**DEMONSTRATION / DELIVERY HOLD - Safety Recall 15S25**

Certain 2016 Model Year F-53 and F-59 Vehicles  
Transmission Shift Cable Bracket Replacement

## CERTAIN 2016 MODEL YEAR FORD F-53 MOTORHOME AND F-59 STRIPPED CHASSIS VEHICLES — TRANSMISSION SHIFT CABLE BRACKET REPLACEMENT

FIGURE 1

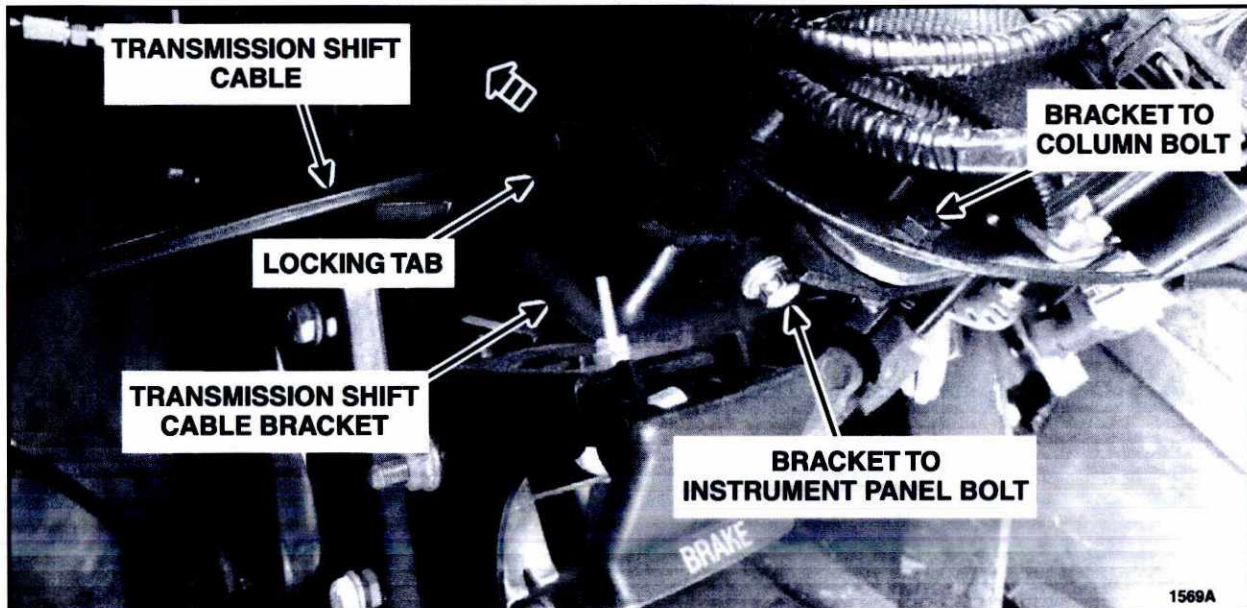
In the affected vehicles, the transmission shift cable bracket may have been manufactured out of specification, causing the transmission shift cable to be installed incorrectly. This condition may result in unintended vehicle movement if force is applied to the gear shift lever when in the park "P" position. Unintended vehicle movement may increase the risk of an injury or crash. Dealers are to replace the transmission shift cable bracket and adjust the shift cable (selector lever cable) using the following procedure.

1. Remove the lower steering column trim/knee bolster panel as necessary to gain access to the lower steering column area. Refer to the Coach Builders Repair Manual for additional information if necessary.
2. Remove the transmission shift cable bracket. See Figure 1.
  - a. Carefully lift the locking tab and disconnect the transmission shift cable from the bracket.
  - b. Remove the two bolts and the transmission shift cable bracket.
    - When installing the bolts, torque to the following specifications:
      - Bracket to Column bolt to 36 lb.ft (48 Nm).
      - Bracket to Instrument Panel bolt to 21 lb.ft (28 Nm).

3. To install the *new* transmission shift cable bracket, reverse the removal procedure.
4. Perform the Selector Lever Cable Adjustment procedure. Please follow Workshop Manual (WSM) procedures in Section 307-05.
